SERVICE LETTER

No. 864

Piper Aircraft Corporation

Forward Cabin Door Stop (Striker Plate)
Installation

RIGHT SIDE
OF
AIRCRAFT

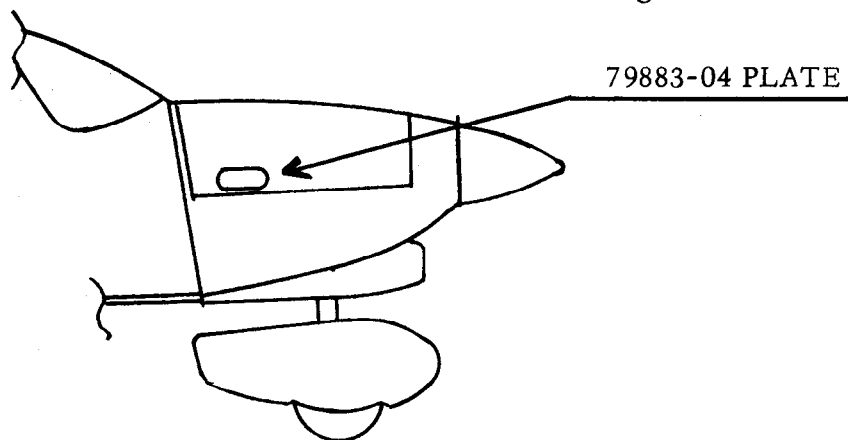
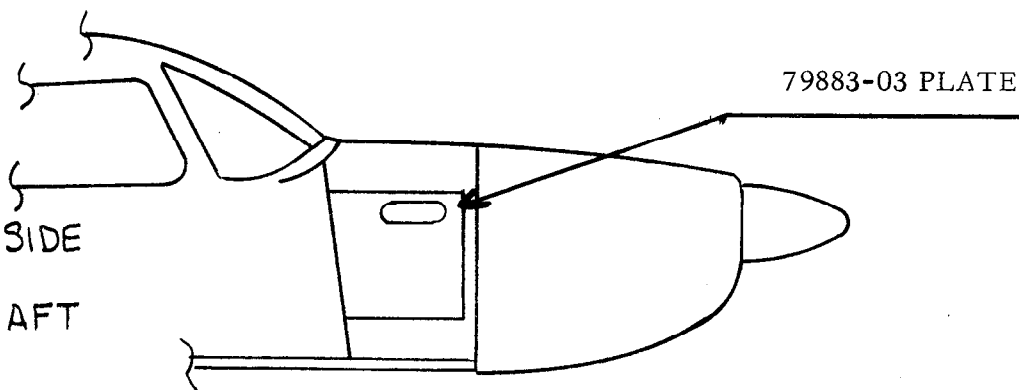
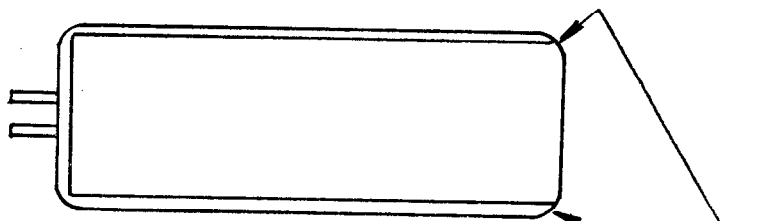
There is a possibility that should a high wind shear the rivet in the forward cabin door holder (stay), the door could swing beyond its normal limit and contact the fuselage or engine cowling. If this happens, the door handle can damage the fuselage or cowling.

PART I provides instructions for installing a striker plate on the fuselage or cowling to prevent damage. The instructions also require the rounding off of the corners on the outside door handle which will assist in moving the handle to the closed position should the handle contact the striker plate.

3. Open the outside door handle (full open) and mark the fuselage or engine cowling at the point where the end of the door handle contacts either the baggage door or the engine cowling. See PART I sketch.

7. With the forward cabin door outside handle fully open, grind off the forward top and bottom corners to .50 radii. See PART I sketch.
8. Reinstall the forward cabin door holder (stay) attachment screw in the door sill which was removed in Instruction number 1.

GRIND CORNER TO
OBTAIN .50R.

4. Install the striker plate (see Material Required for correct plate for model concerned), using the previously determined point of contact from Instruction 3, to locate the forward attaching rivet.

5. Align the striker plate parallel with the bottom edge of the cowl or; where the striker plate is installed on the forward baggage door, align the striker plate parallel with the upper hinge line of the baggage door.

6. Install the striker plate using two (2) each Piper part number 420 693 (MS20426-A3-7) rivets. Where the striker plate is installed on a fiberglass cowling, use one (1) each Piper Part Number 407 560V (AN960-3) Washer next to the fiberglass on the bucked end of each rivet.
